APPLICATION NO.	FILING DATE	FIRST NAMED INVENTOR	ATTORNEY DOCKET NO.	CONFIRMATION NO.
10/806,739	03/23/2004	Harry N. Mason	G595A	2560

Office Action Summary

DETAILED ACTION

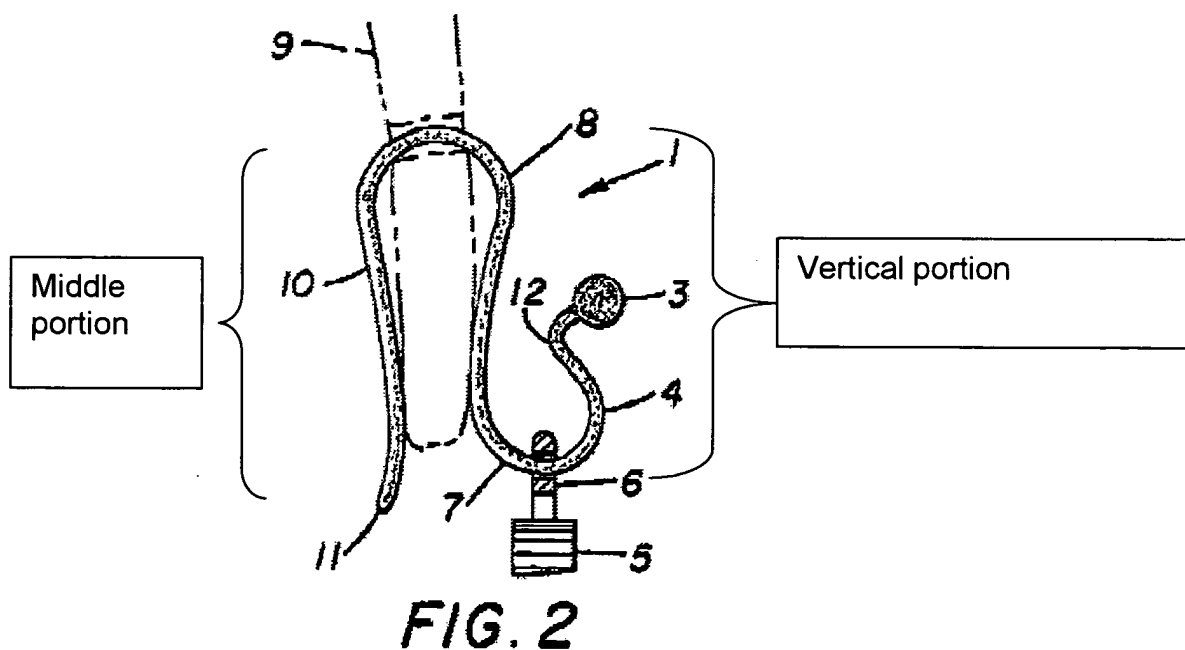
Re claim 1: Chicckine shows in Fig 2 a secure interchangeable earring for use with a pierced ear, the earring having a charm with a charm opening, and further comprising a body formed from a single integral piece of substantially uniform cross section, the body comprising a free end (11) for threading through the pierced ear (9) and sized to extend through the charm opening (6) (col 1 line 62 - col 2 line 3), a blocked end (3) to prevent dislodgement of the charm from the earring thereat; an apex portion (that portion in the ear hole), a vertical portion between the apex and the blocked end, and another middle portion (16) between the apex and the free end.

Chicckine further teaches a charm (5) with a charm opening (6 - seen in cross section in the figures), and shows the body (1) sized to allow the charm to move fully from the free end to the blocked end, such that when the earring body is threaded onto the ear with

FIG. 8

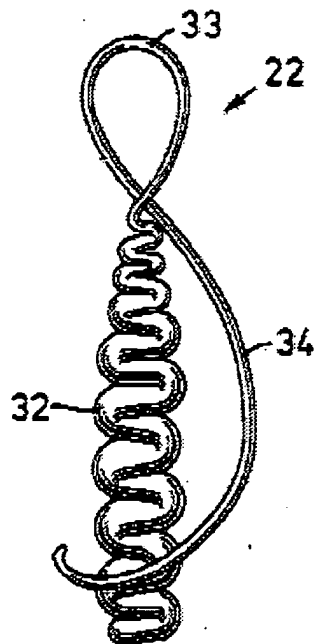
the apex at the pierced hole, the charm is trapped between the blocked end and the pierced hole (shown in both figures). However, Chicckine lacks that the middle portion between the free end and the apex is spiraling. Mason teaches an earring with an apex and a spiraling section for additional decoration in the figures, especially Figs 2 and 8:

Therefore, it would have been obvious to one of ordinary skill in the art, having the teachings of Chicckine and Mason before him at the time the invention was made, to modify Chicckine as taught by Mason to include the decorative spiral of Mason, in order to obtain a more decorative and versatile earring, as Mason teaches in col 1 lines 60-63 that it is an advantage to have part of the attachment portion also serve as a decorative feature, (referring to the spiral).
